Cycle Winchester Response to an Application for Planning Permission at Bushfield Camp

Application Ref: 23/02507/OUT

Bushfield Camp, Badger Farm Road, Winchester, SO23 9RZ

6th December 2023

The St Cross Road roundabout

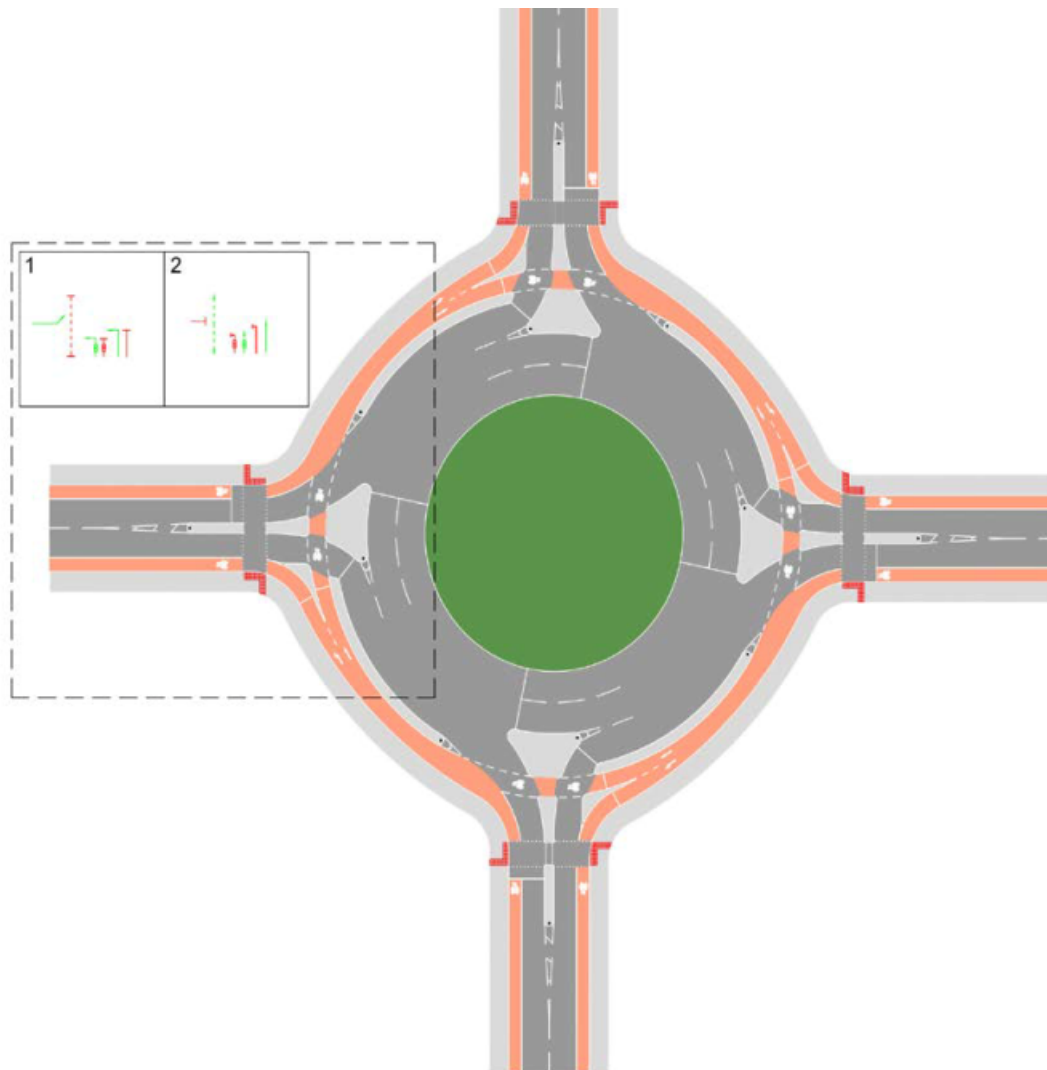
Signalised crossing of the major roads around St Cross roundabout is not ideal for cyclists in principle, though it may be the pragmatic choice. Our main concern is that the design of the crossing points is needlessly indirect, with many right-angled turns, and does not conform with LTN 1/20.

See LTN 1/20 section 10.7 on roundabouts, 5.9 on horizontal curve radii, and Summary principle #18:

18) Cycle routes must flow, feeling direct and logical. Users should not feel as if they are having to double back on themselves, turn unnecessarily, or go the long way round. Often, cycling schemes - when crossing a main road, for instance - require cyclists to make a series of ninety-degree turns to carry out a movement that a motor vehicle at the same location could do without turning at all. Schemes should be based on a proper understanding of how people actually behave rather than how they might be expected to behave.

The proposed roundabout design does almost exactly the opposite of this. The diagram below highlights the tortuous and hazardous route the cycleway around the roundabout takes (green dotted line) compared to the on-road route.:

We note also that the proposed design increases the number of entry and exit lanes on some arms of the junction, as well as on the west side of the roundabout. For vehicular cyclists (of which there are currently many) this greatly increases the risk involved in traversing the roundabout. A 2018 statistical study concluded that *“The probability of a serious [cyclist] casualty increases by approximately five times (odds ratio 4.97) for each additional number of lanes on approach.”*¹

The crossing should be streamlined for cyclists, including attention to signal sequence, otherwise the painful crossing of this junction will become a major deterrent to a group whom the applicant is keen to persuade to cycle.
